From: Graeme Means <gmeans@highmesacg.com>
Sent: Thursday, December 02, 2021 4:26 PM
To: Biazar, Shahab
Cc: Justin Schara; Trujillo, Timothy R, NMDOT; Aaron Zahm; Brian Verardo
Subject: FW: [EXTERNAL] RE: Los Altos Park - Phase I (K20D037) Drainage Comments

Subject: Los Altos Park - Phase I (K20D037) Drainage Comments

How the SNOUT Works

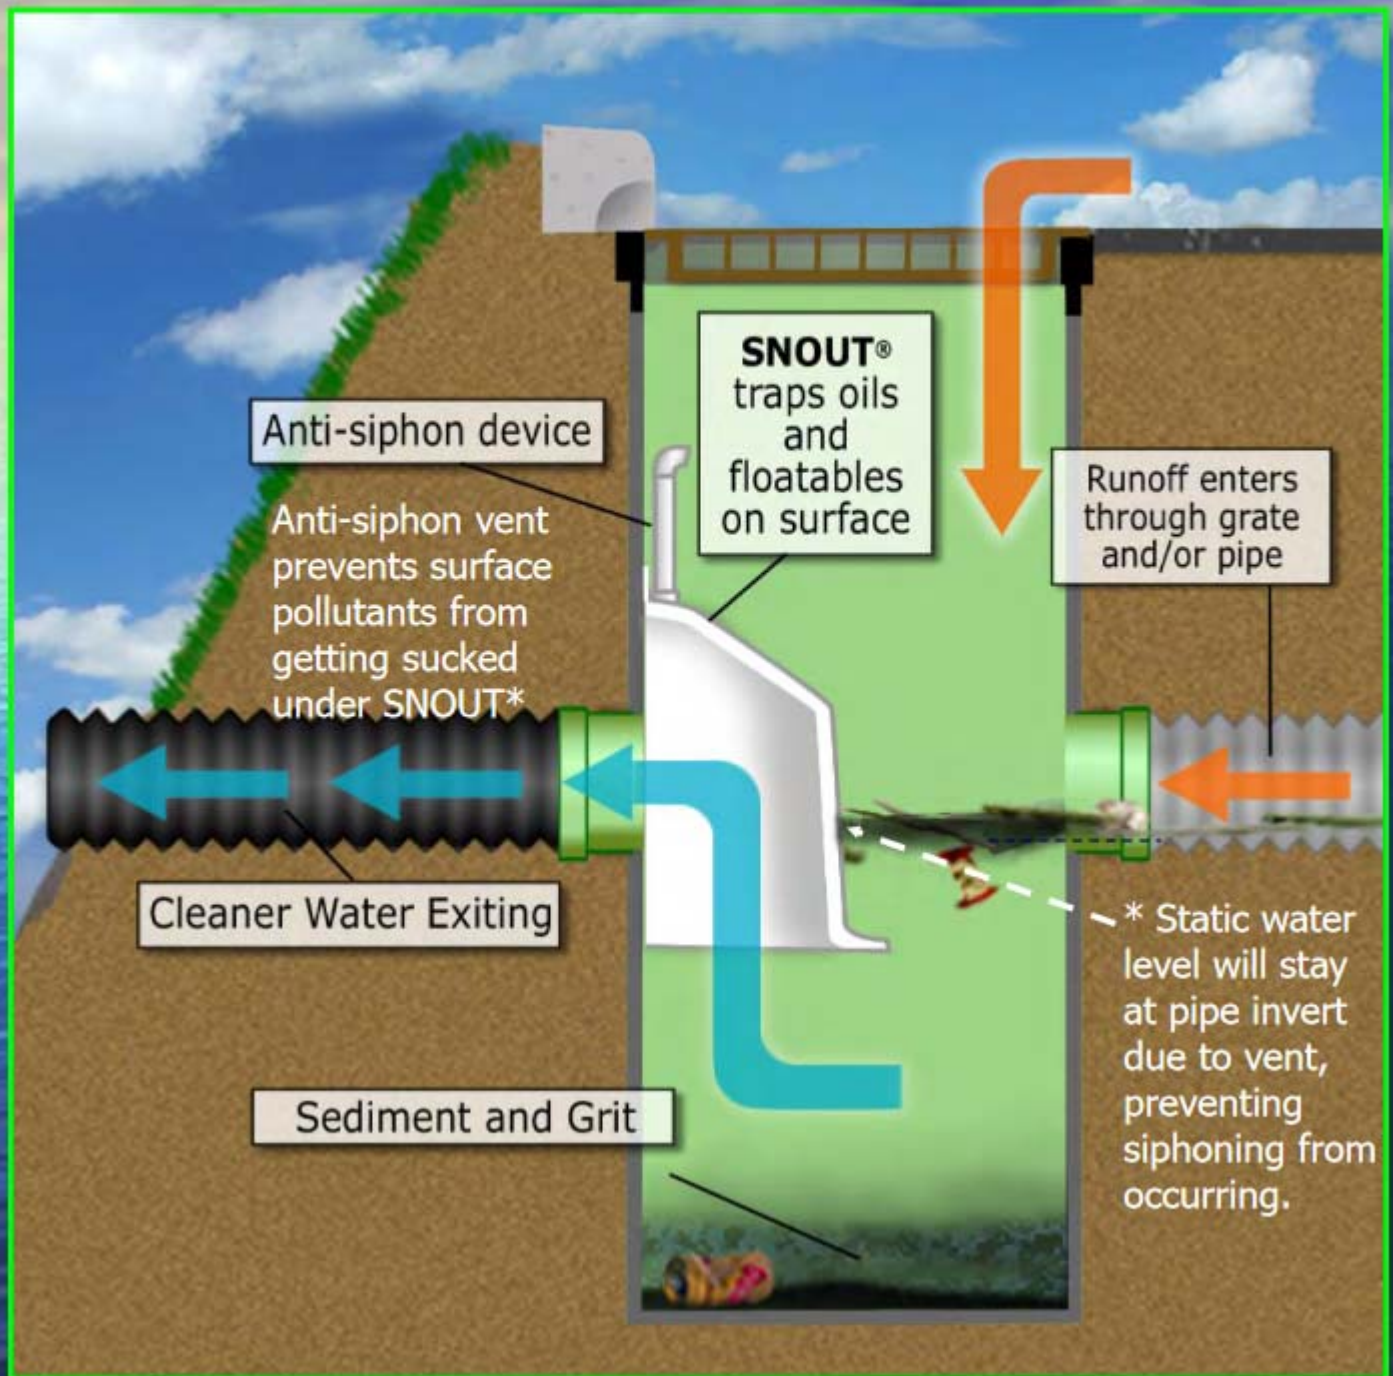
The City does not have a standard detail. They look and work as below.

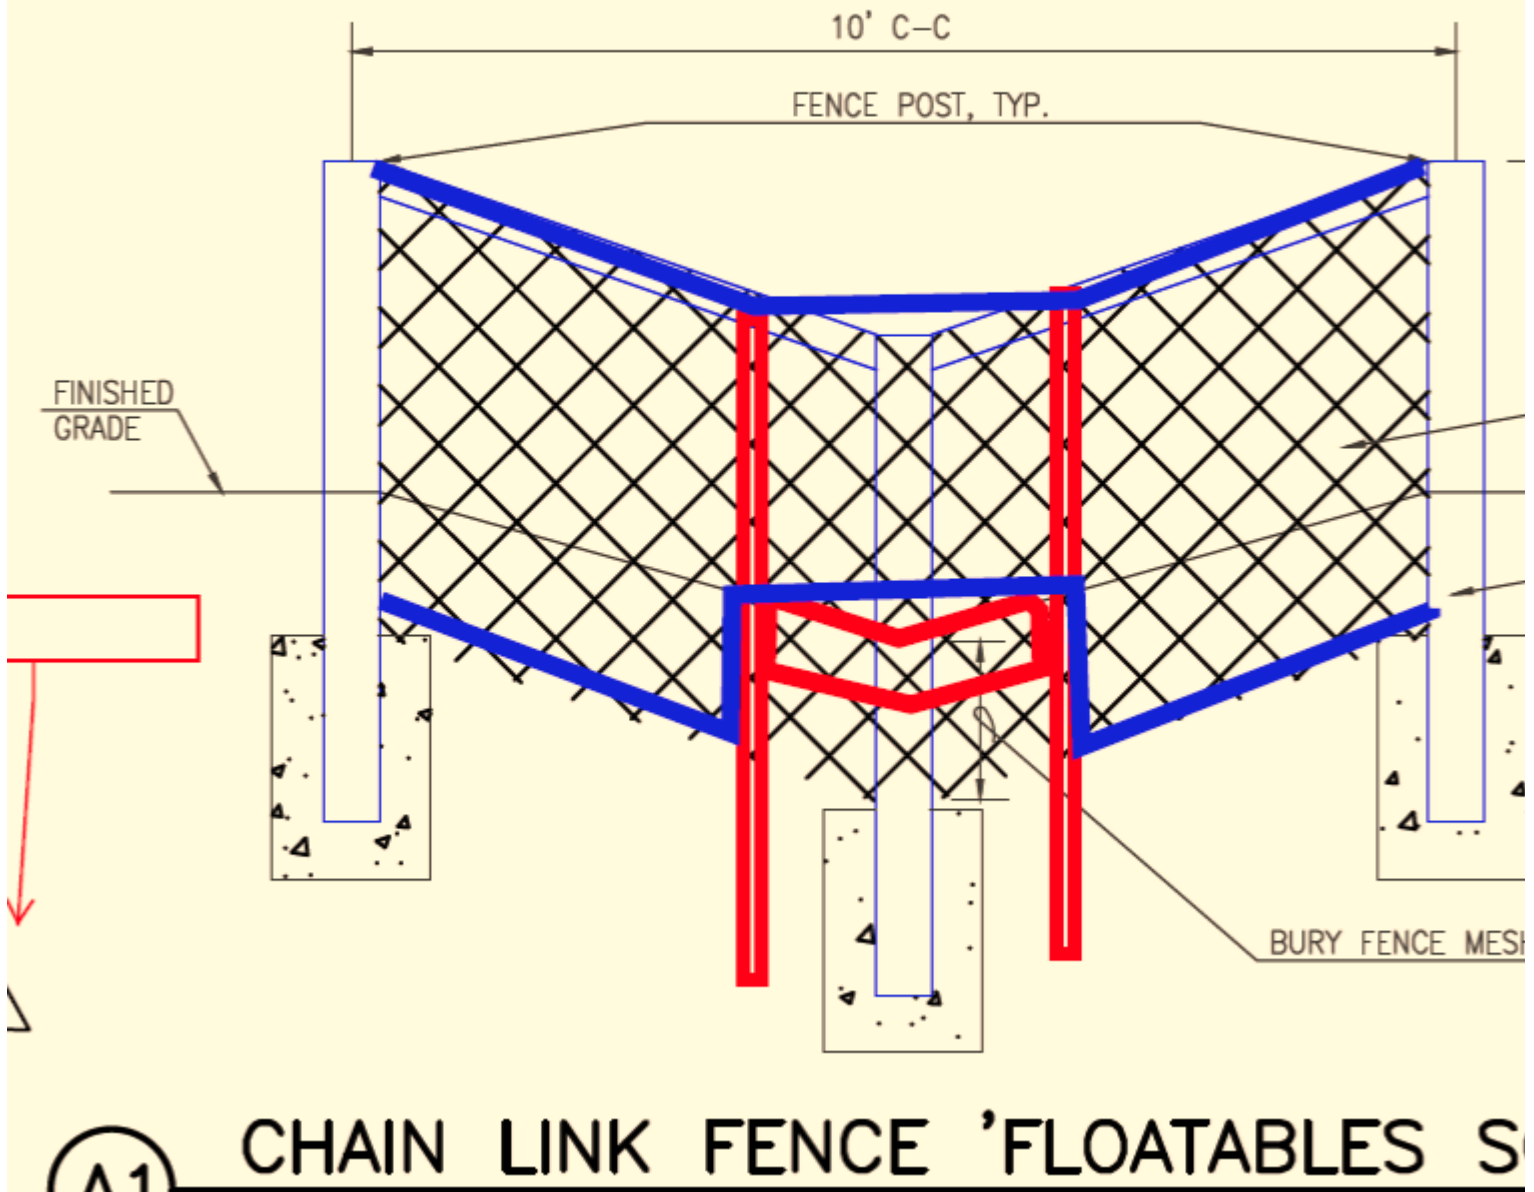
I reviewed this with Graeme and we believe we can do this. The existing valley gutter stops even with the fence line, so instead of a 'V' shape, we are thinking of replacing a couple panels of the existing fence line with a detail similar to the sketch below, where the fence would be buried on either side of the valley gutter and then straddle gutter itself.

Can the screen be placed at the end of the valley gutter in COA property? Any debris would be generated in City jurisdiction.

I have no issues with the hydrology. The only remaining comments are from our meeting. No HDPE as a connection to NMDOT inlets and could you provide a floatable screen (chain link fence buried 1') in the existing swale to the eastern NMDOT 54" culvert connection to the arroyo. This can be placed at the end of the concrete valley gutter. I'll see if I can find a detail for this.

The detail looks good! I also have no further comments on the plans. For my own records, does COA have a standard detail for the snout? Please let me know if any thing should change.
